COMMISSION ON COMMUNITY INVESTMENT AND INFRASTRUCTURE

RESOLUTION NO. 34-2020

CONDITIONALLY APPROVING AMENDMENTS TO THE REVISED MAJOR PHASE FOR BLOCKS 41-43 APPLICATION AND THE BASIC CONCEPT / SCHEMATIC DESIGN FOR MISSION BAY SOUTH BLOCK 43, PARCEL 7 (1450 OWENS STREET) TO DEVELOP A MIXED-USE LIFE SCIENCES FACILITY; AND, ADOPTING ENVIRONMENTAL REVIEW FINDINGS PURSUANT TO THE CALIFORNIA ENVIRONMENTAL QUALITY ACT; MISSION BAY SOUTH REDEVELOPMENT PROJECT AREA

East Elevation

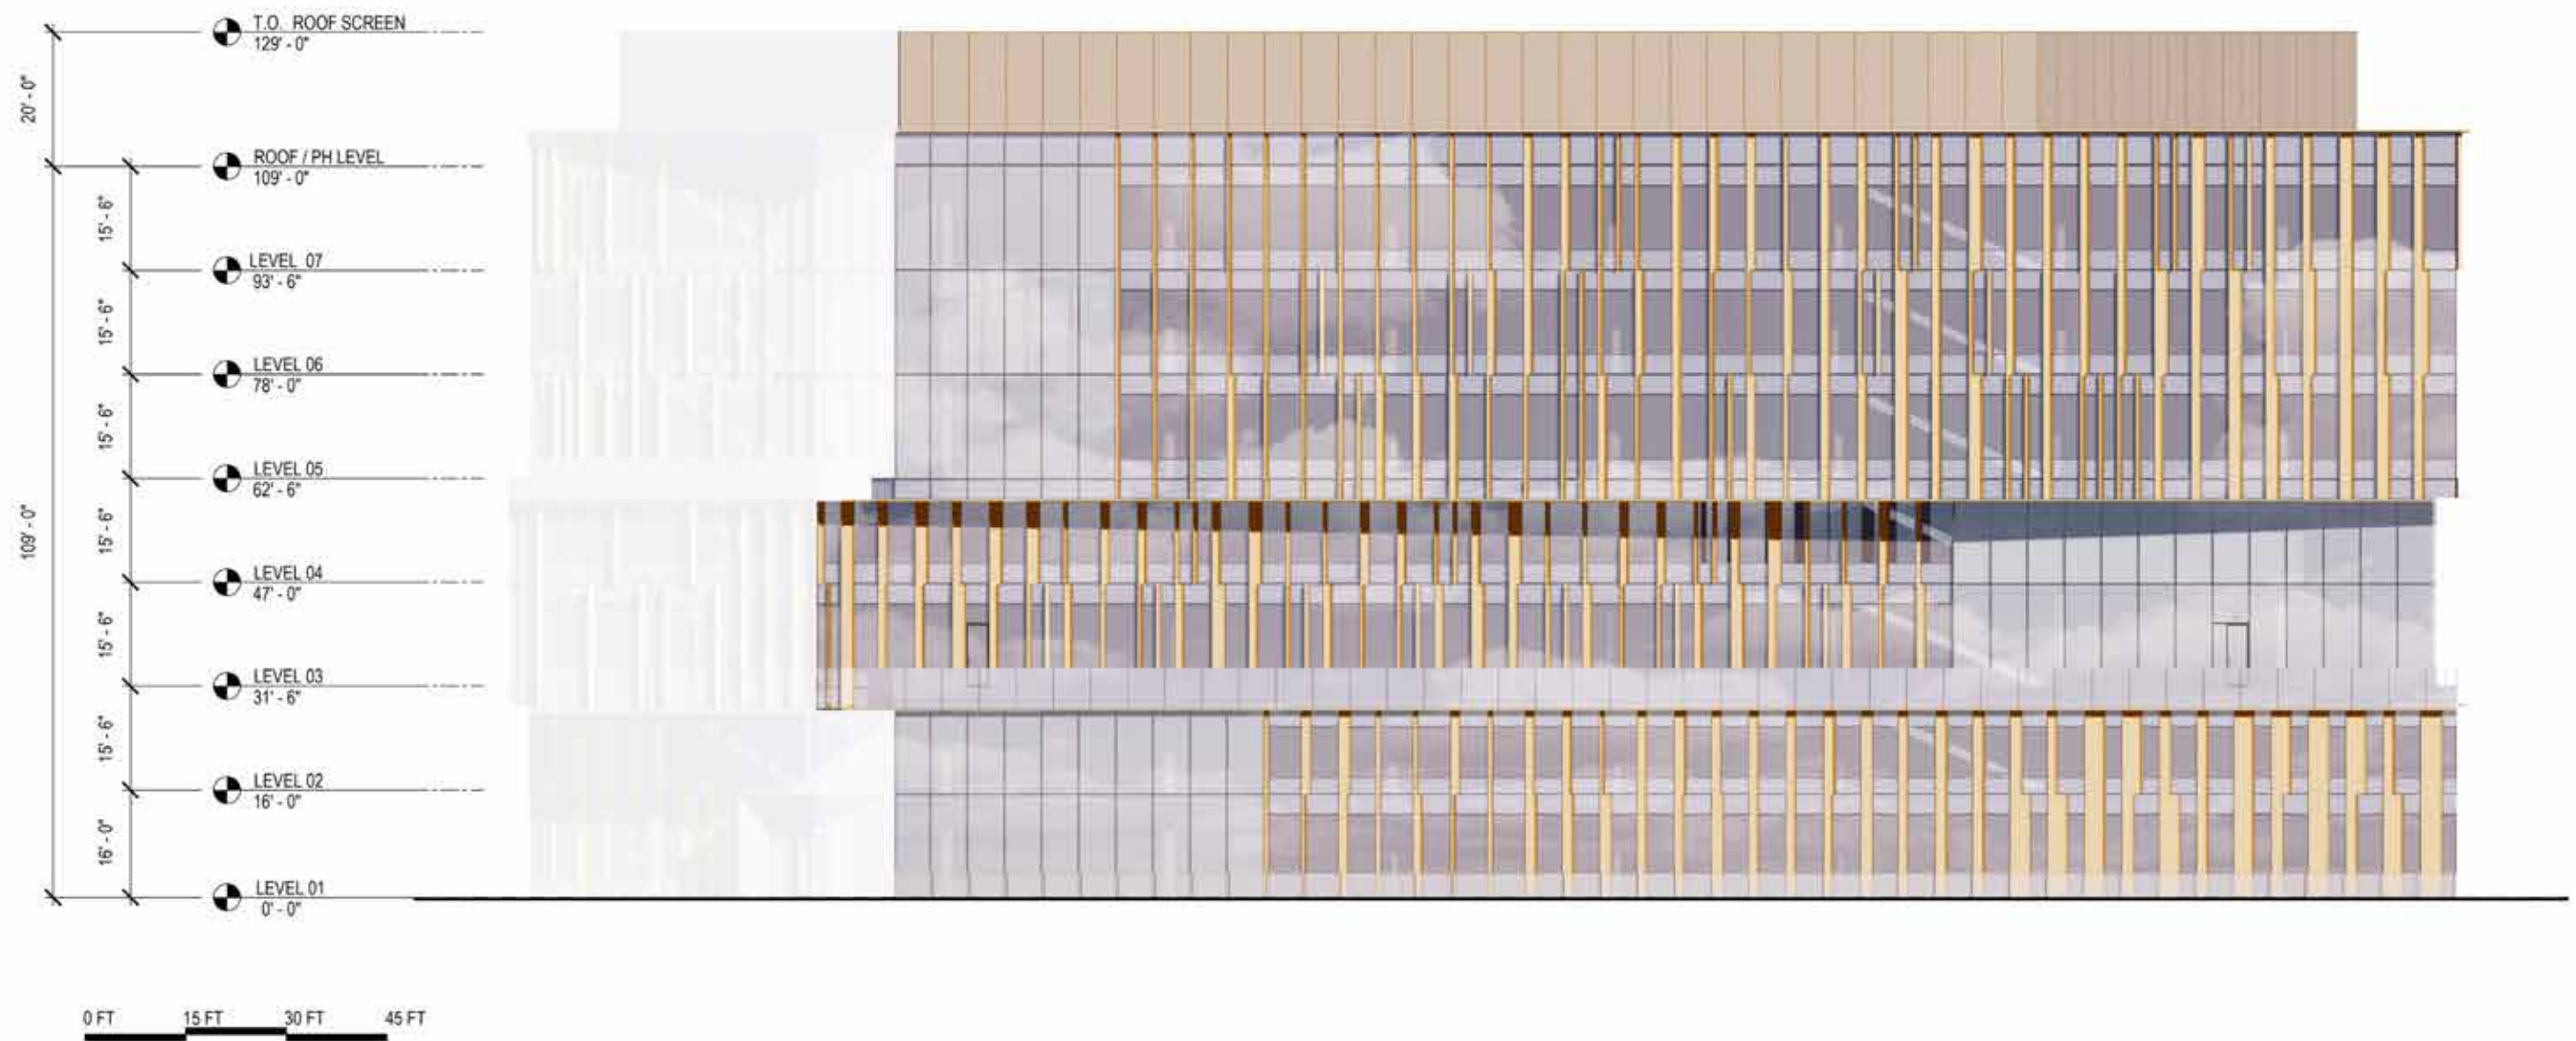
11. Blank Walls / Utility Room Screening. Refine the screening, materiality and architectural treatment of all ground-floor utility rooms and garage doors, especially the West Elevation where there is a large expanse of blank wall area. Doors and utility frontage should screen mechanical uses while providing visual interest to the public realm through incorporation of design features such as high-quality materials, texture, artistic expression and transparency. The proposed aluminum panel screening at the West Elevation shall be further developed in coordination with OCII staff.

Facade Details

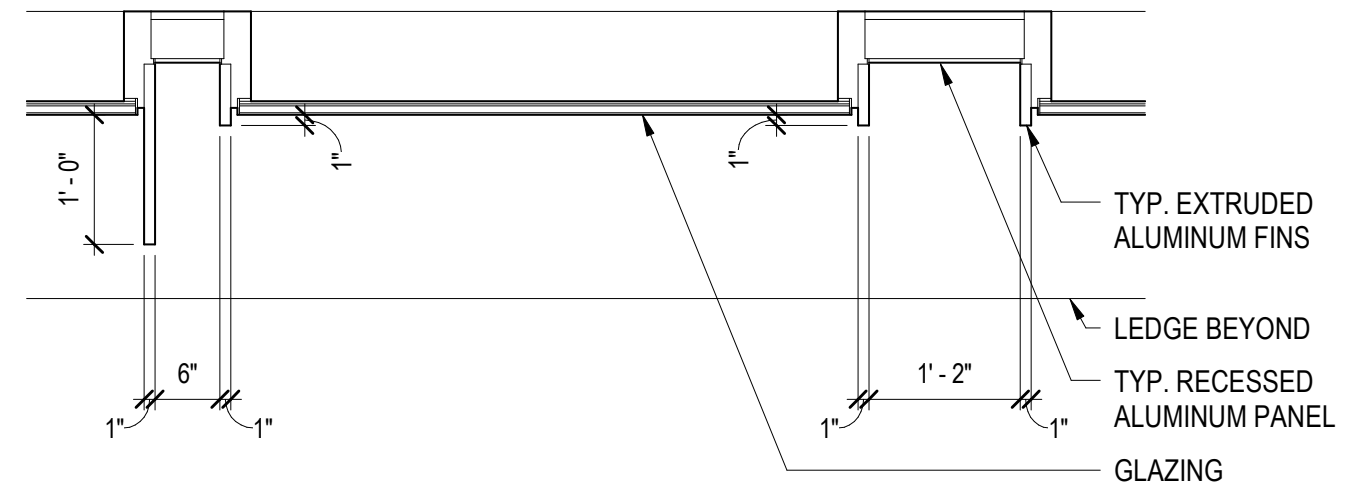
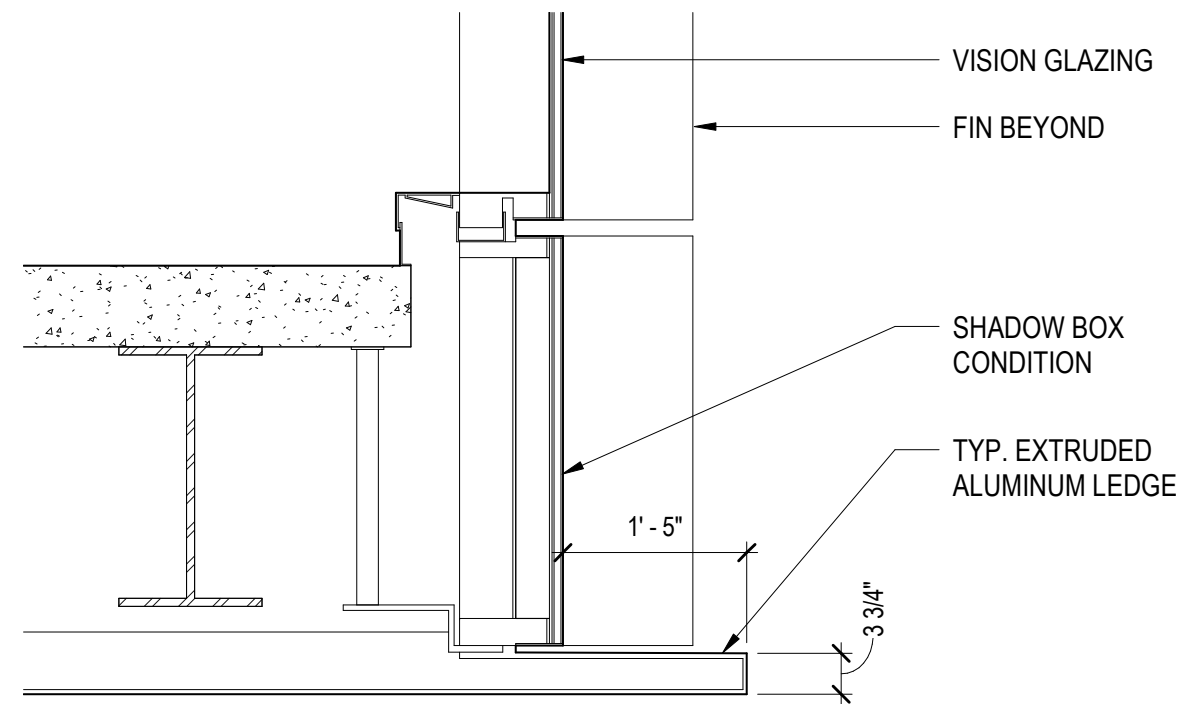
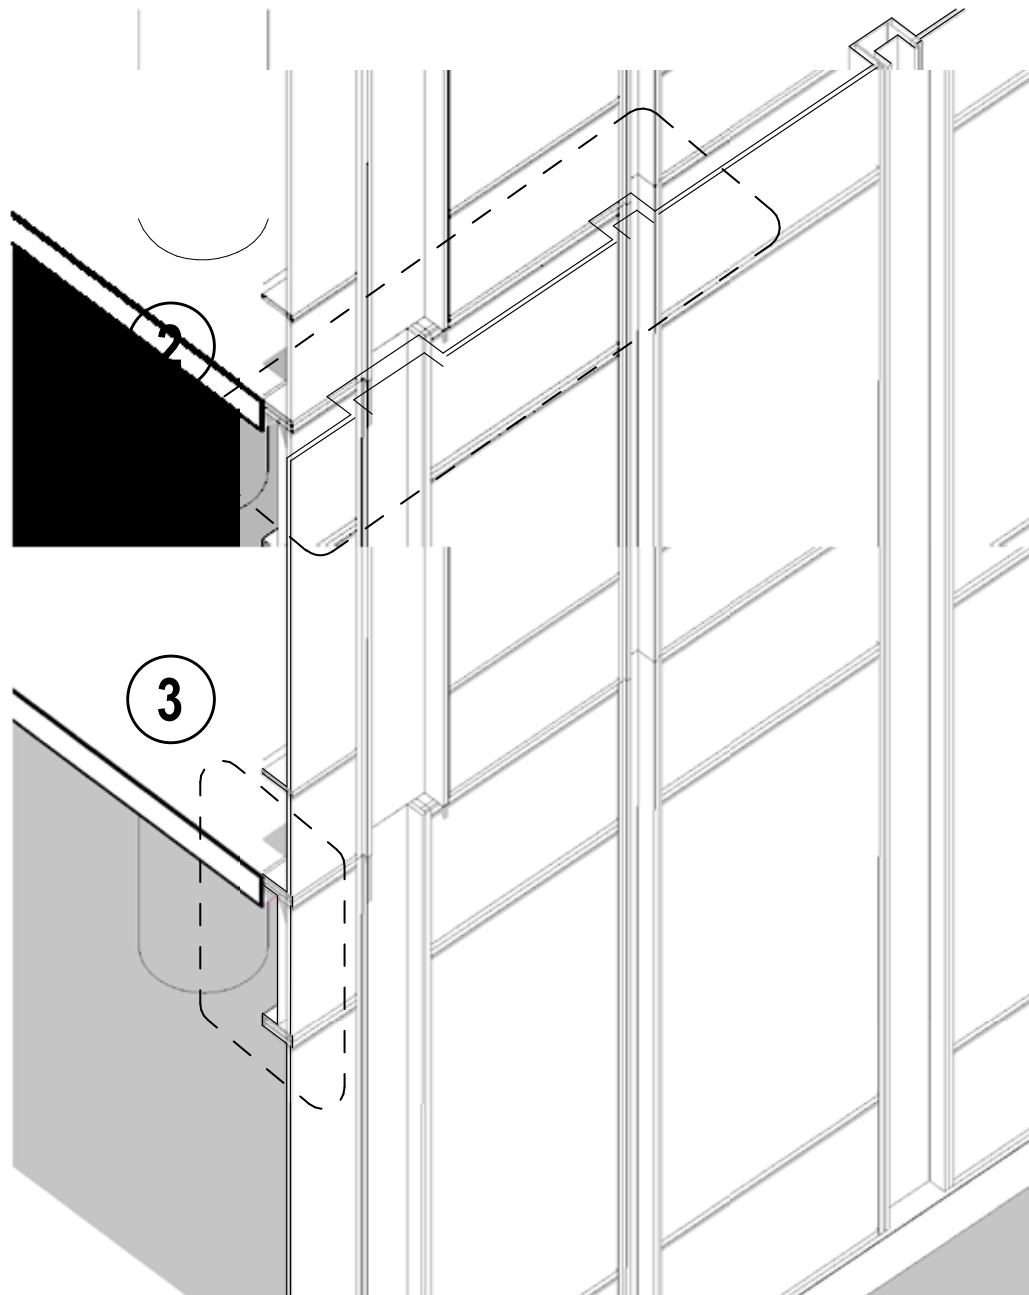
3. Materials and Colors. Continue to develop and refine the building materials palette, wall systems, glazing, screening and other materials, in coordination with OCII staff. Materials palette must demonstrate durability, quality, color, variety, graffiti-resistance, and visual interest, especially at the ground floor. Explore opportunities to incorporate locally sourced materials to establish a palette that works with climate, light, neighborhood context, history, and culture. Sustainable and recycled materials are highly encouraged. Physical material and color samples shall be provided to OCII in advance of mock-up design and construction.

5. Architectural Mock-Up Construction. Prior to procuring façade materials, construct a physical material mock-up to allow for OCII, design team, and contractor review of material durability, texture, color and detail installation.

Exterior Lighting Concept

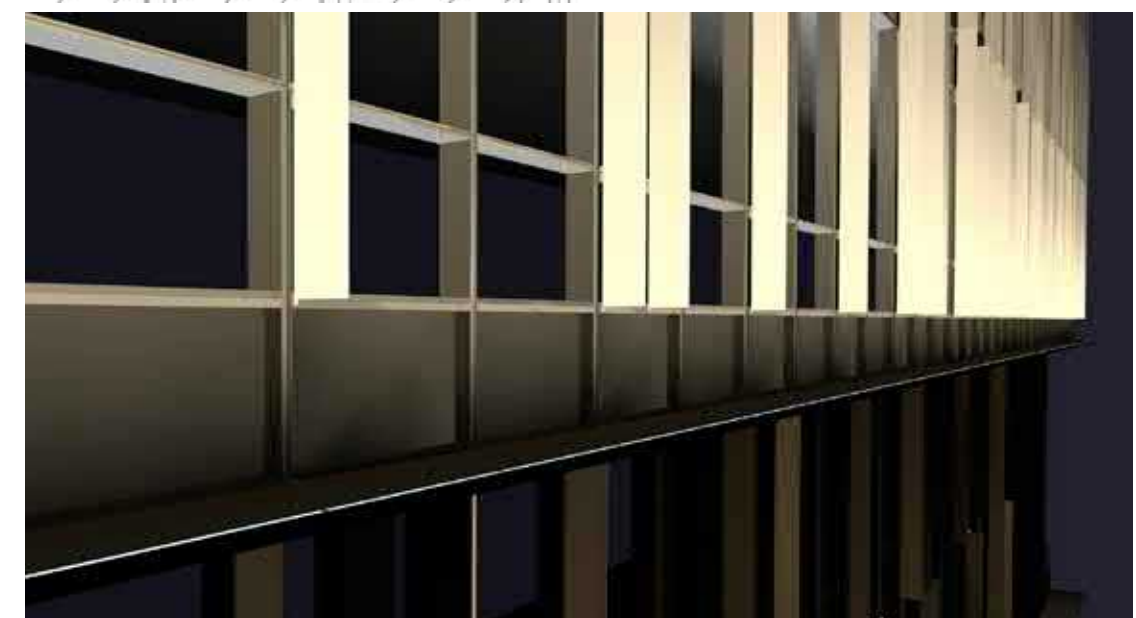
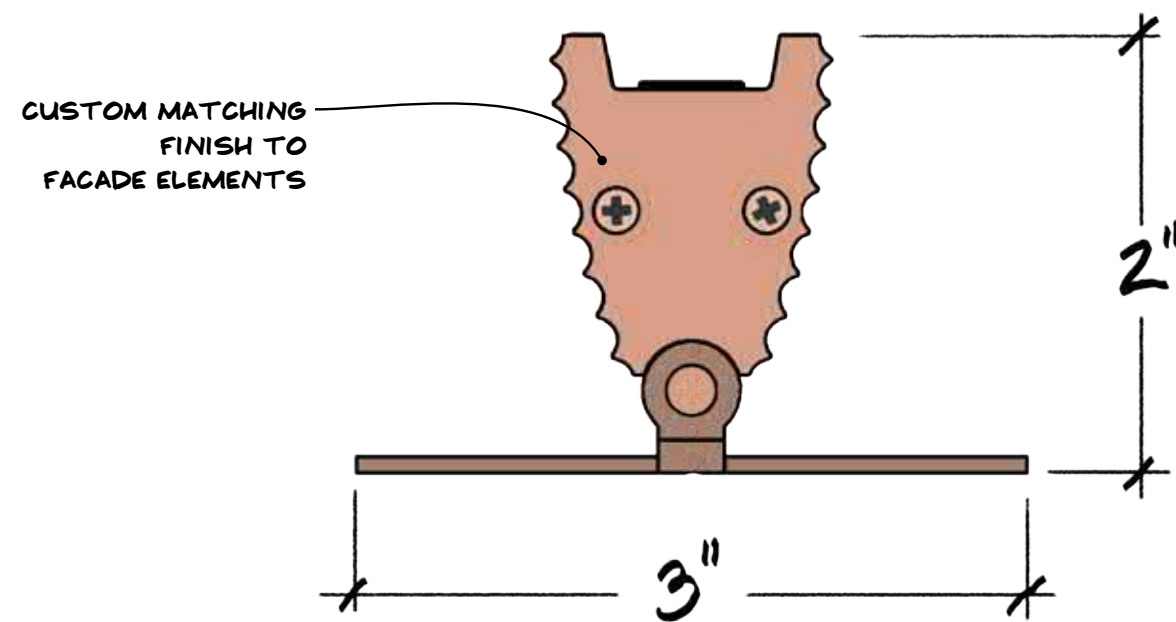
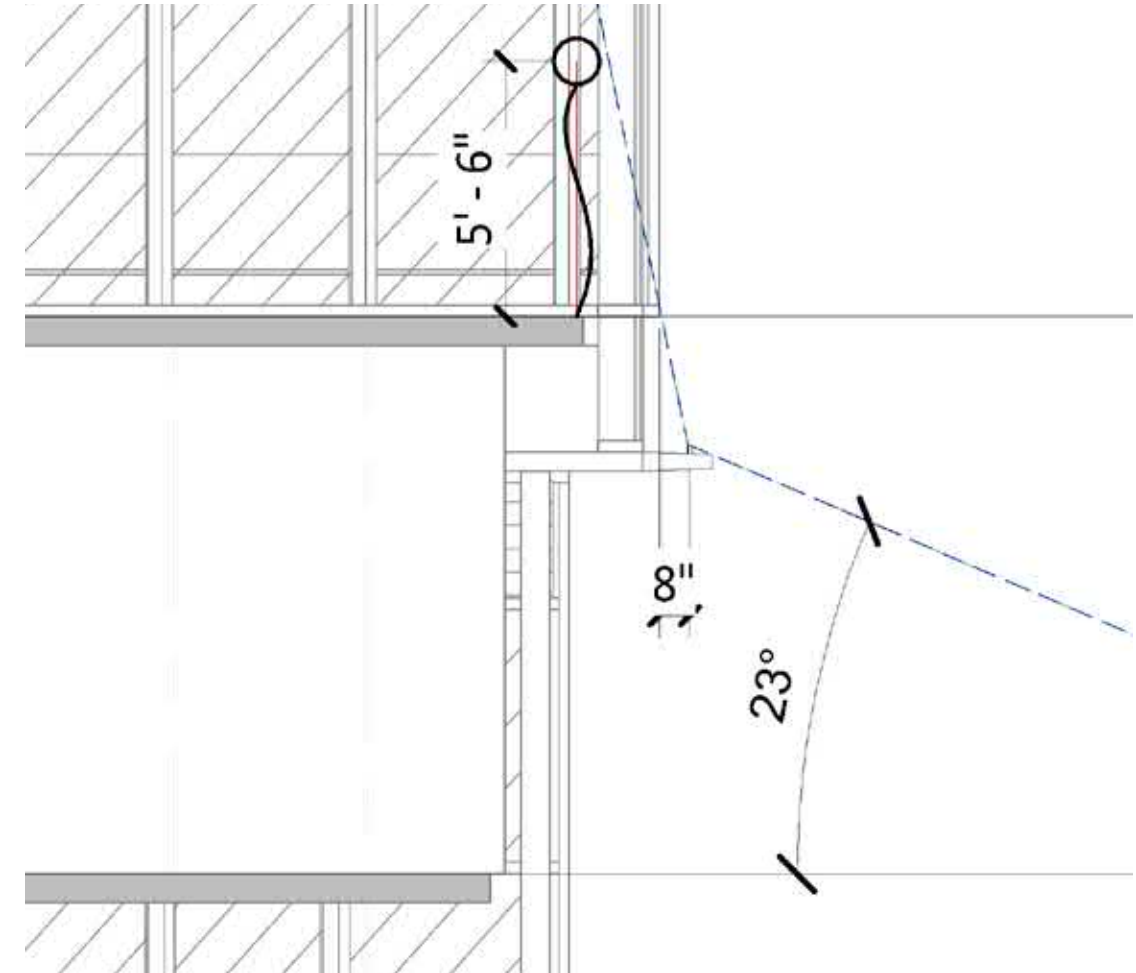
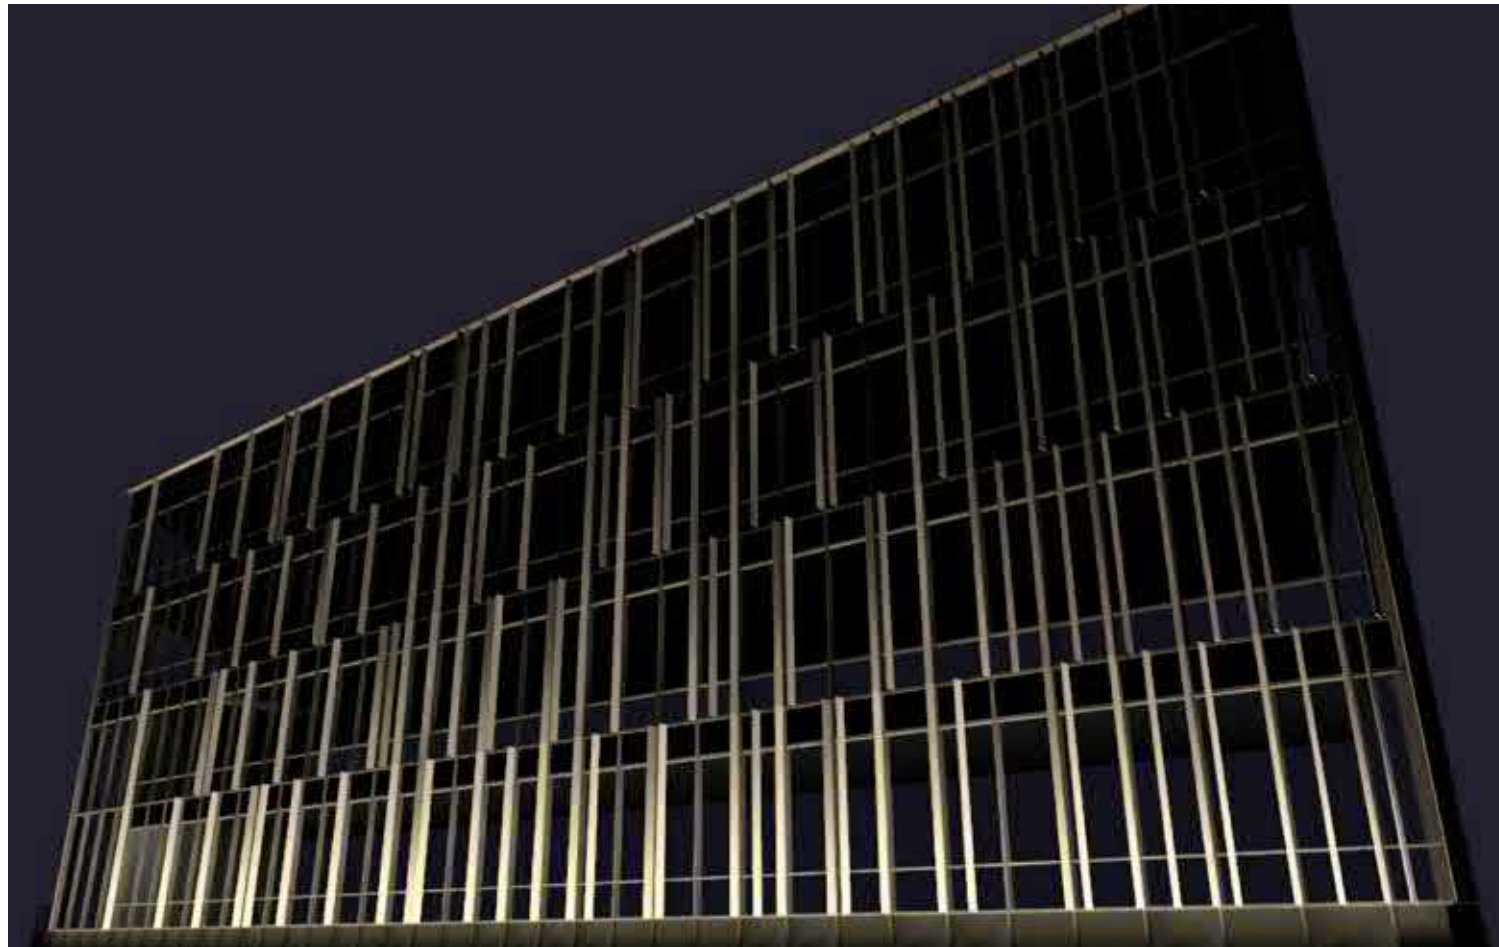
14. Lighting Plan. Provide a detailed building lighting plan. Lighting should be subtle and reinforce the overall façade design.
15. Signage. All building signage shall be subject to further OCII staff review and approval. Developer shall submit a signage plan prior to or concurrent with the Design Development submittal, pursuant to the Mission Bay South Signage Master Plan.
